## Addendum #2

Directorate of Facilities Engineering

**Waterville Armory Roof Repair Project, 74 Drummond Road, Waterville, Maine, DFE Project Number 23SR23-406-D, BGS Project Number 3625, Bid Number 23-028.**

SHEET ID:  
**R-103**  
 SHEET: 7 OF 10

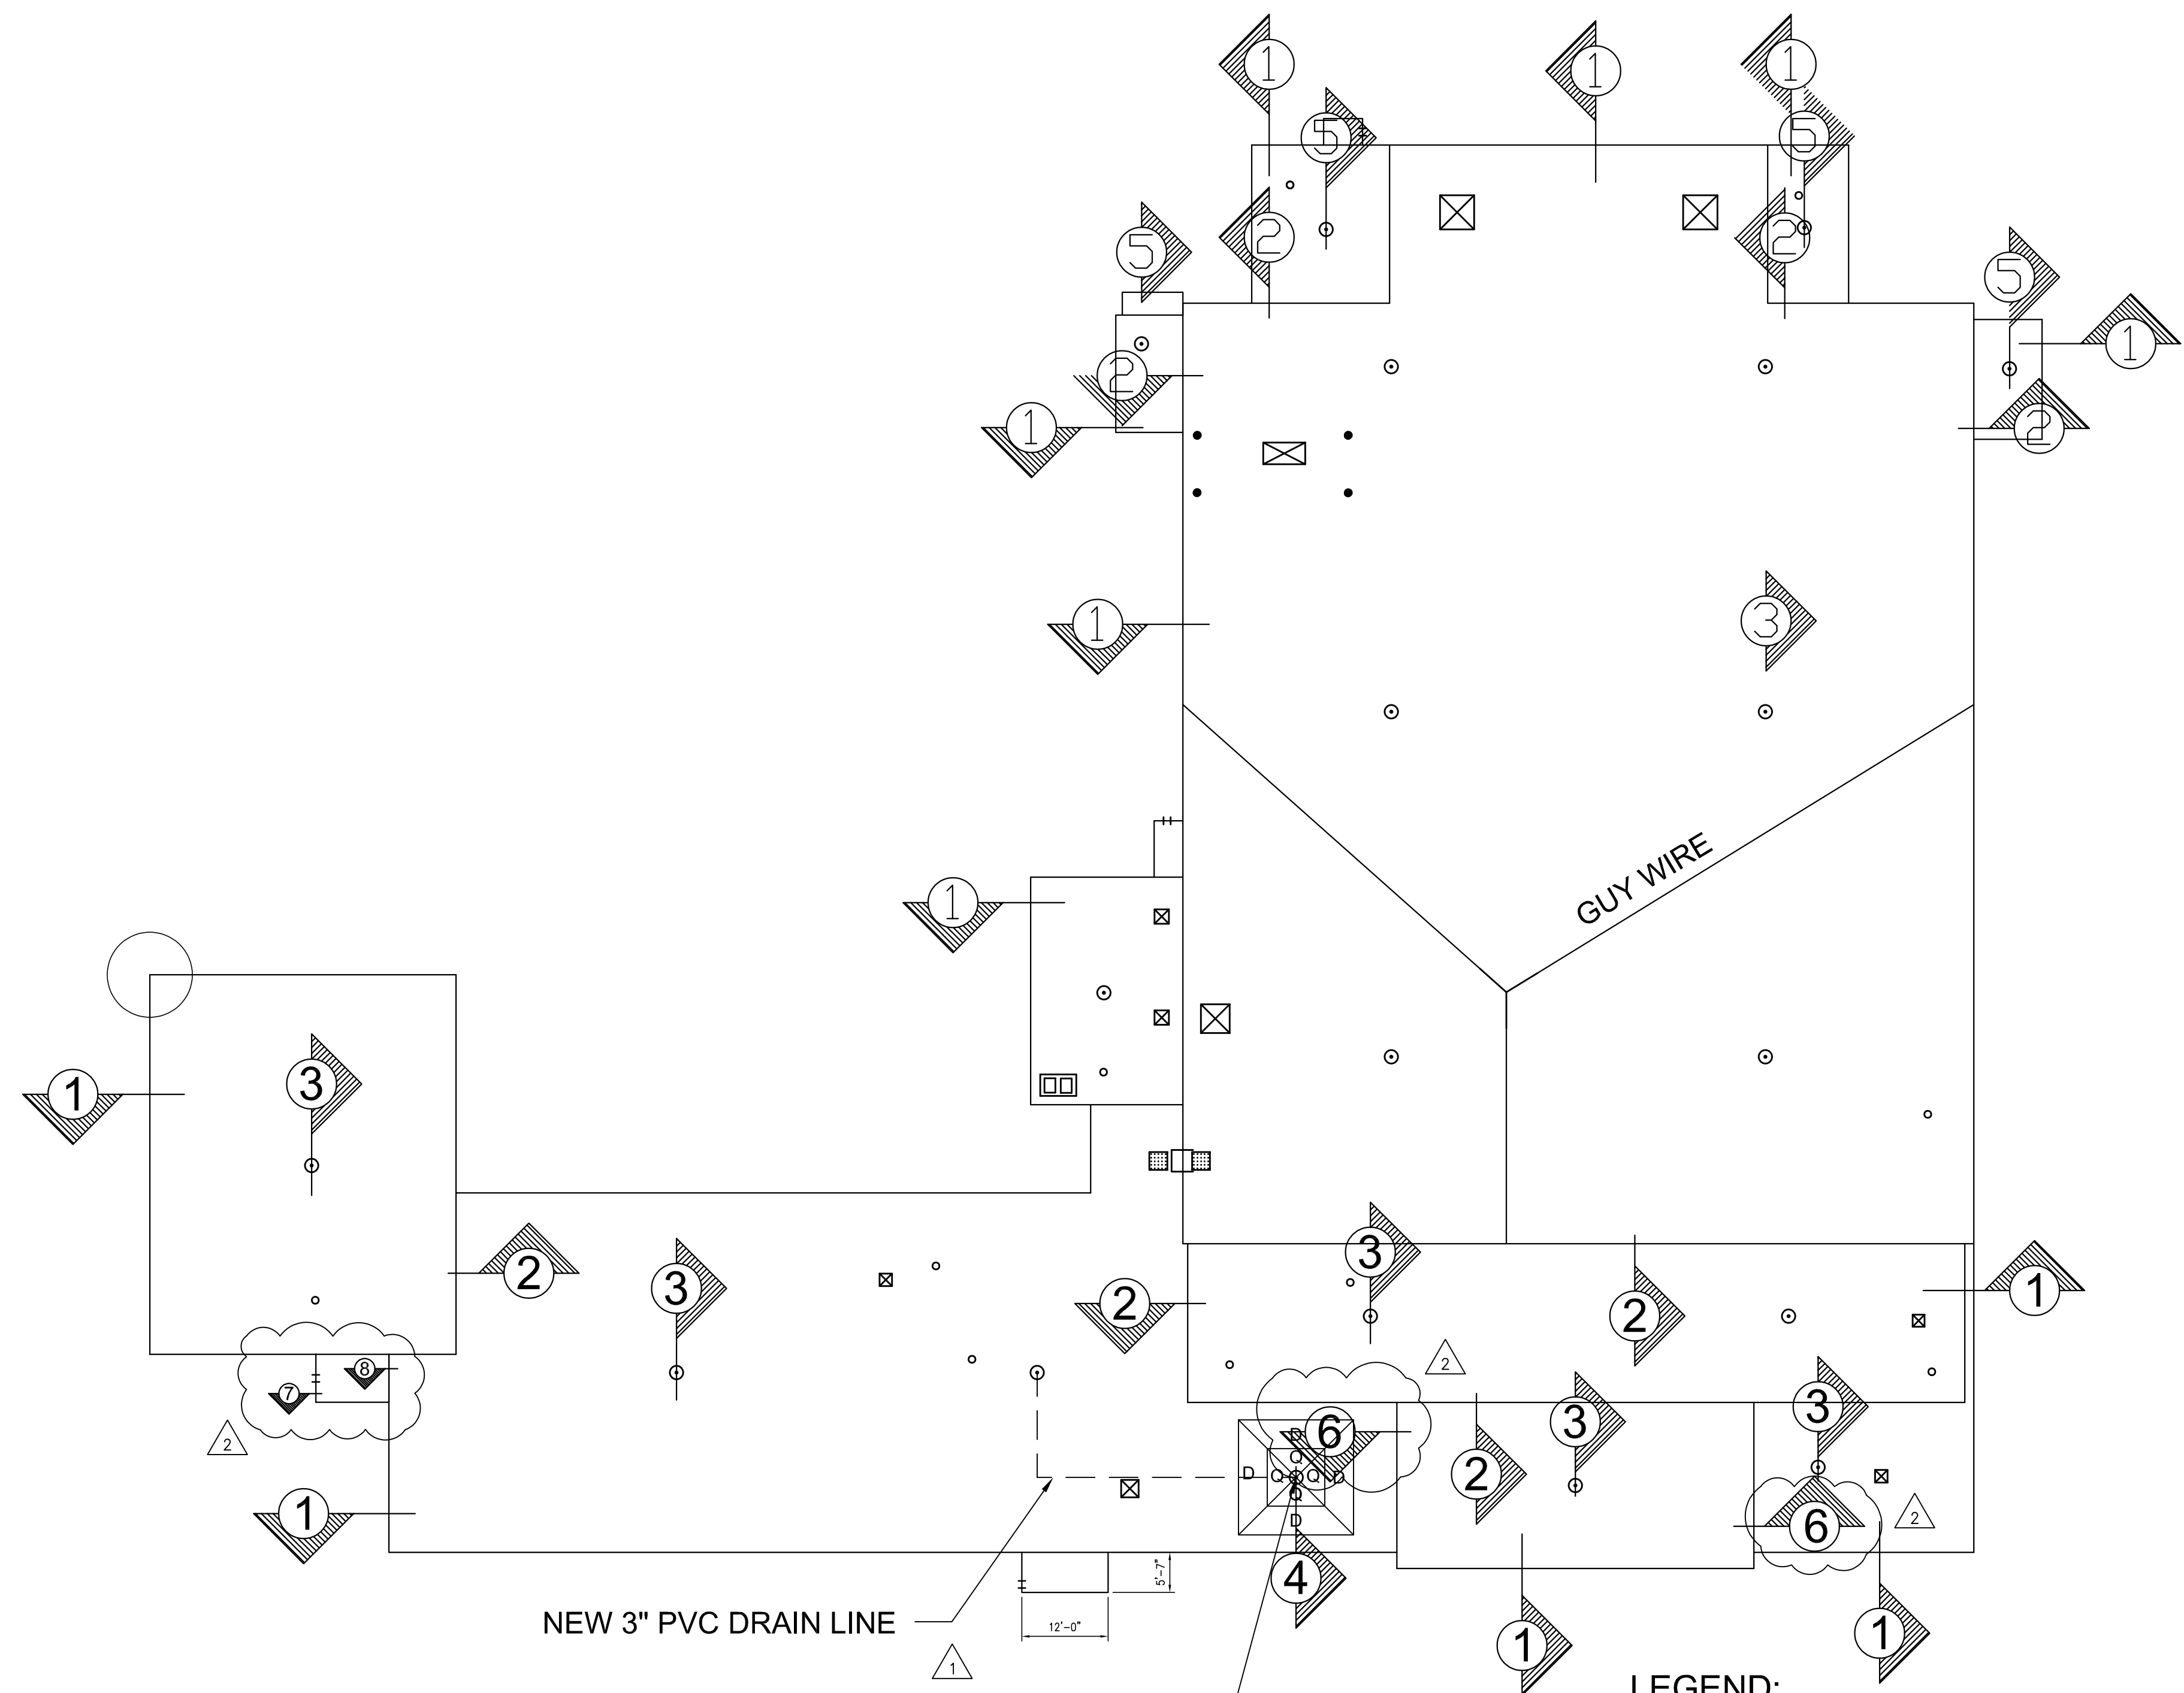
1. Replace Drawing Sheet R-103 – Proposed New Roof Plan, with new revised Drawings Sheet R-103 – Proposed New Roof Plan.
